DEV	/ELOPMENT ASSESSMENT REPORT
Application No.	MOD/2020/0156
Address	24 Catherine Street LEICHHARDT NSW 2040
Proposal	Modifications to designappearance of three approved dwellings.
Date of Lodgement	21 May 2020
Applicant	Traders In Purple 113 Pty Ltd
Owner	Traders In Purple 113 Pty Ltd
Number of Submissions	Nil
Value of works	\$1,191,615.00
	\$2,891.48
Reason for determination at	
Planning Panel	delegation
Main Issues	FSR variation, streetscape presentation
Recommendation	Approved with Conditions
Attachment A	Recommended conditions of consent
Attachment B	Plans of proposed development
Attachment C	Clause 4.6 - FSR
38 36 34 32 30 30 28 26 26 24 22 20 18 18 19 10 14 11 10 14 5 8	44 49 47 38 45 45 45 45 45 45 45 45 45 45 45 45 45
	LOCALITY MAP
Subject Site	Objectors
Notified Area	Supporters

# 1. Executive Summary

#### **ADD CONDITION 3A**

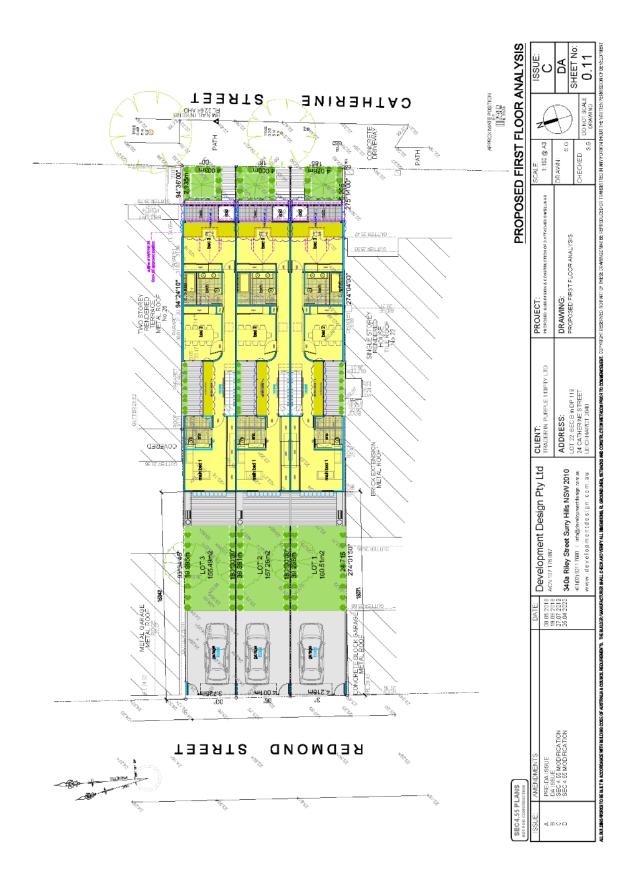
Council raises no objection to the infill of the central voids for each dwelling as these voids are wholly located within the building envelope and will improve the internal amenity of each dwelling. However, the infill of the first floor at the Catherine Street elevation is not supported for all three dwellings – namely the infill of Lot 1 (southern lot). Catherine street is characterised by a variety of dwelling styles as such any infill development should provide a suitable transition between the dwellings immediately adjoining the site to the north and the south. Immediately to the south consist of single storey cottage style dwellings whilst to the immediately to the north are two storey Victorian style terraces. The proposed infill of the southern lot will contribute to adverse bulk forward of the building line at the adjoining dwellings immediately to the south and as such compromising the streetscape.

Having regard to the above, it is considered that the modified development will not cause any additional amenity or visual impacts for adjoining properties or alter its streetscape presentation with the exception of Lot 1 (the southern lot). Therefore, compliance with the maximum FSR development standard is considered to be unreasonable in the circumstances. The proposed modification involving a departure from the FSR development standard is therefore supported subject to the recommended design change conditions. To ensure that the proposal is consistent with the objectives of the FSR development standard, namely that the development is compatible with the desired future character of the area and minimises bulk at the primary streetscape, it is recommended that the proposed first floor works at the Catherine Street elevation to Lot 1 (southern lot) are deleted from the proposal.

Prior to the issue of a Construction Certificate the works under M/2020/0156 are to delete the infill works at the first floor Catherine Street elevation of the southern lot, also known as Lot 1

FIGURE A

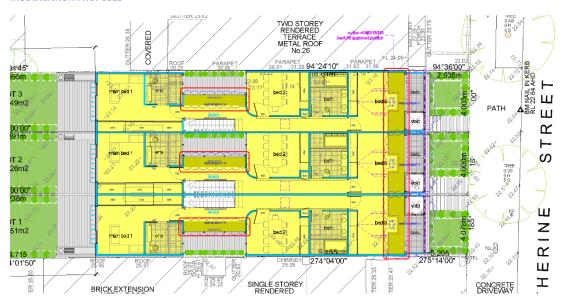
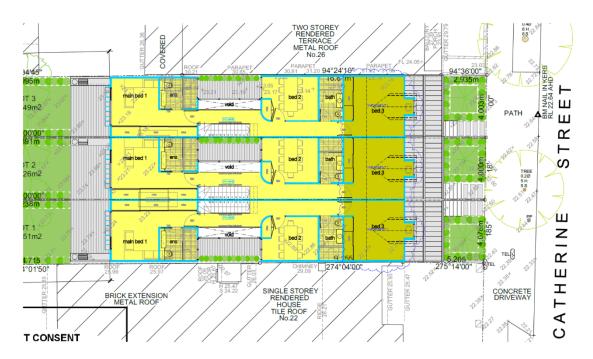
- The reinstatement of 2.64m2 of internal first floor void between the stair and central atrium; (refer Figures A & B)
  - The increase of 3.57m2 of floor area within first floor bedroom 3 as a result of converting the previously Sec4.55 approved traditional pitched and dormer façade to a contemporary infill façade; (refer Figures A & B)
